# TECHNICAL SERVICE BULLETIN

Classification: BT22-007A	Reference: NTB22-068A	Date: July 9, 2024
------------------------------	--------------------------	-----------------------

## WATER LEAKING FROM REAR WIPER ARM PIVOT SEAL

Figure 1

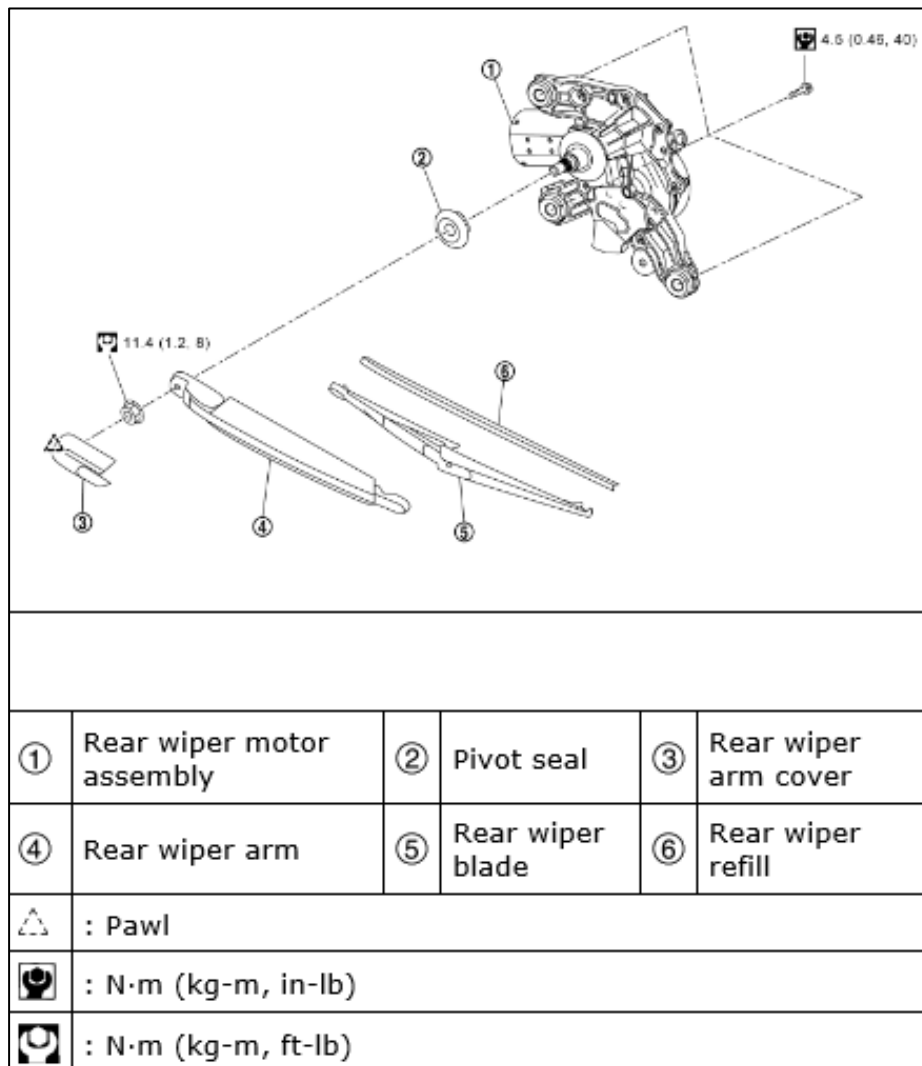
Water is found to be leaking around the rear window wiper arm pivot seal after performing a water soak test.

1. Replace the rear wiper arm pivot seal (#2 in Figure 1).
  - Refer to the ESM: **DRIVER CONTROLS > WIPER & WASHER > REMOVAL AND INSTALLATION > REAR WIPER > WIPER MOTOR**

Replace the rear window wiper arm pivot seal with the one listed in **PARTS INFORMATION** on page 3.

DESCRIPTION	PART NUMBER	QUANTITY
SEAL - PIVOT	28716-JE20A	1
